CONSTRUCTION DOCUMENTS FOR:
HAVEN VALLEY
 (LETA DR.) BRADLEY RD/ALTURAS DR.
 SECURITY, EL PASO COUNTY, COLORADO

v1_Construction Drawings.pdf Markup Summary 10-19-2023

HAVEN COVE POINT
PLAN & PROFILE

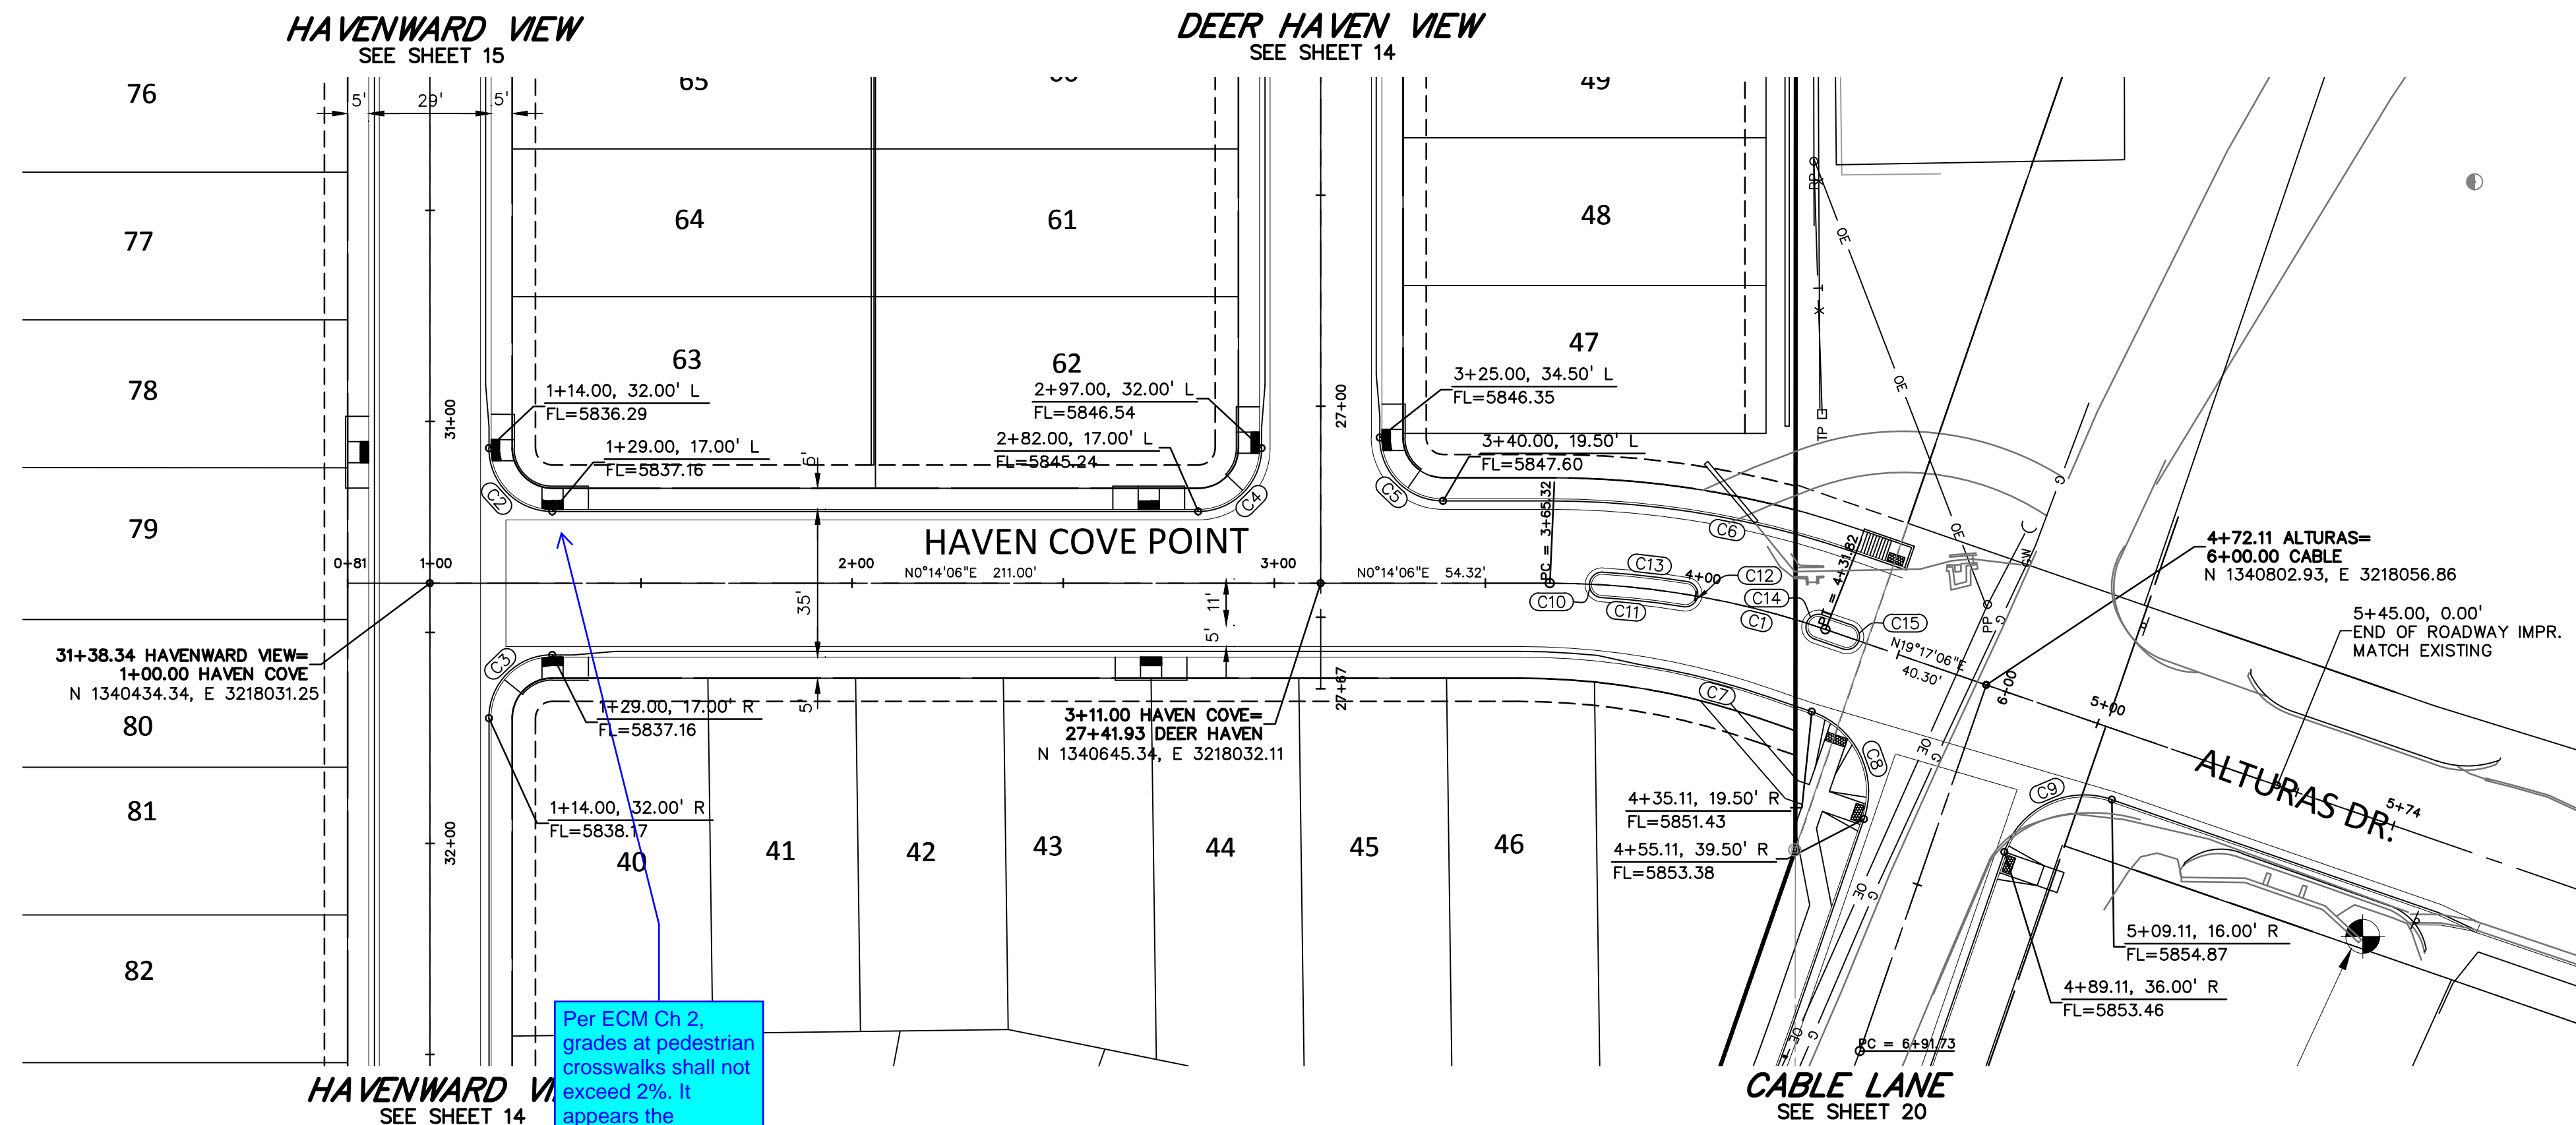
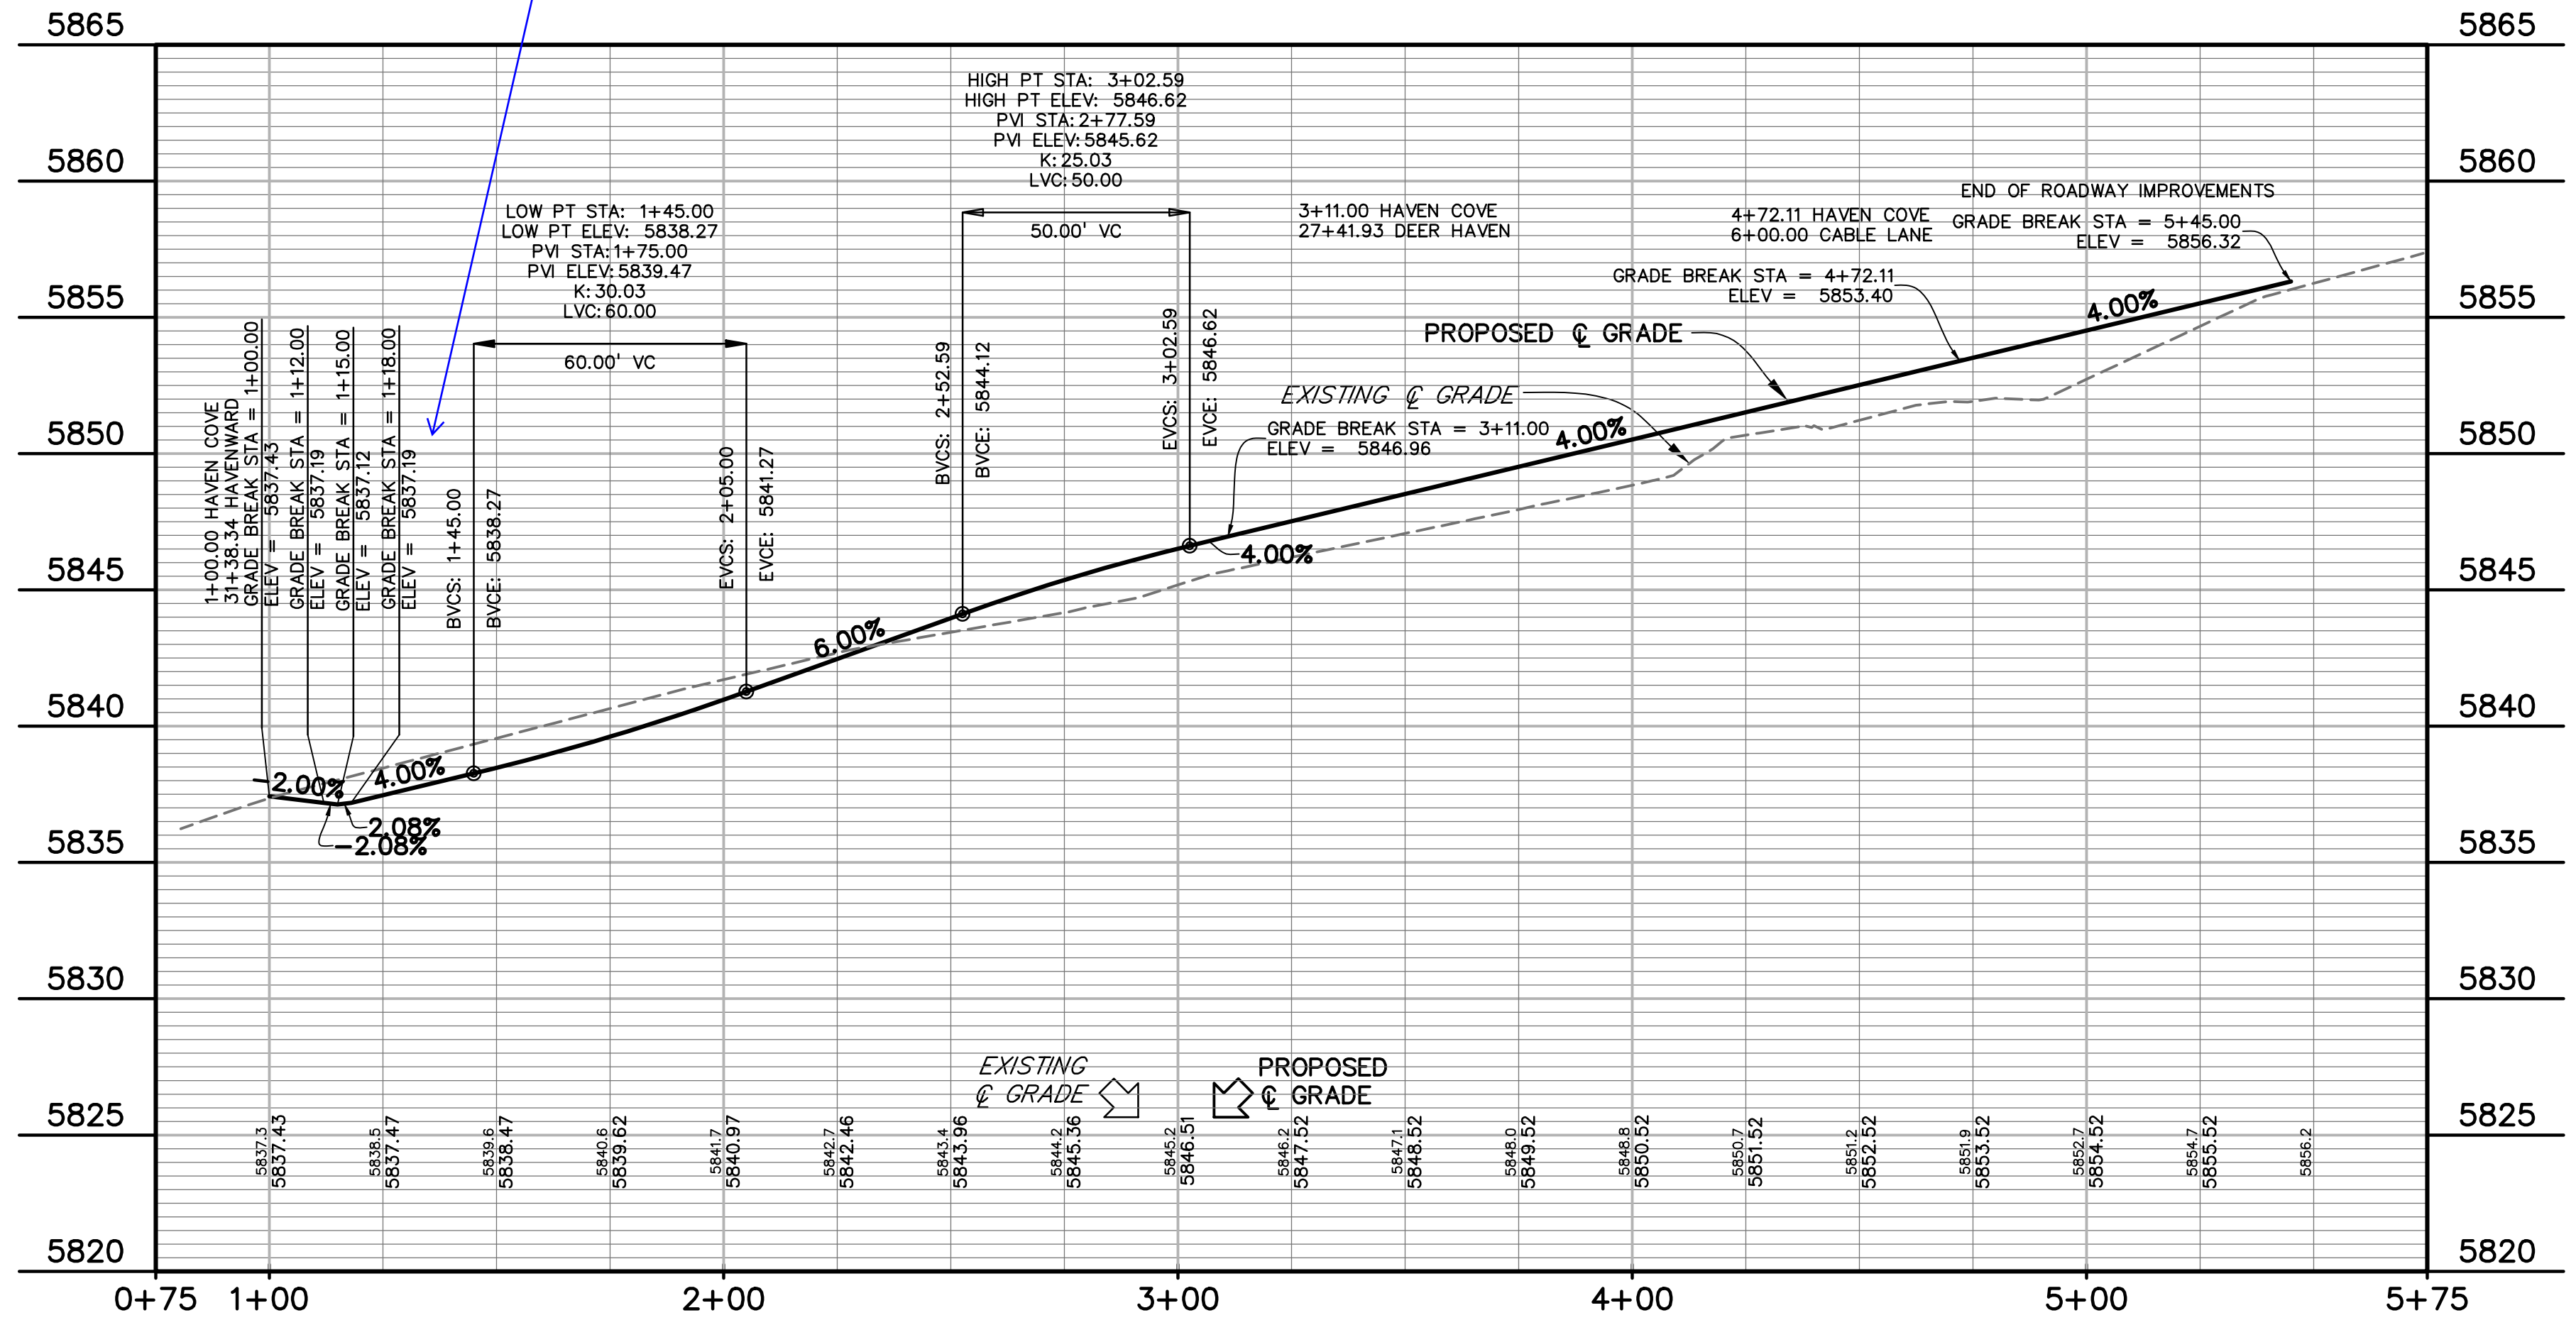
Revise plans to show flowing grade of curb. Per ECM Ch 2 minimum grade is 0.5%.

Update plans to show pedestrian ramp grades if a separate sheet will not be provided for this.
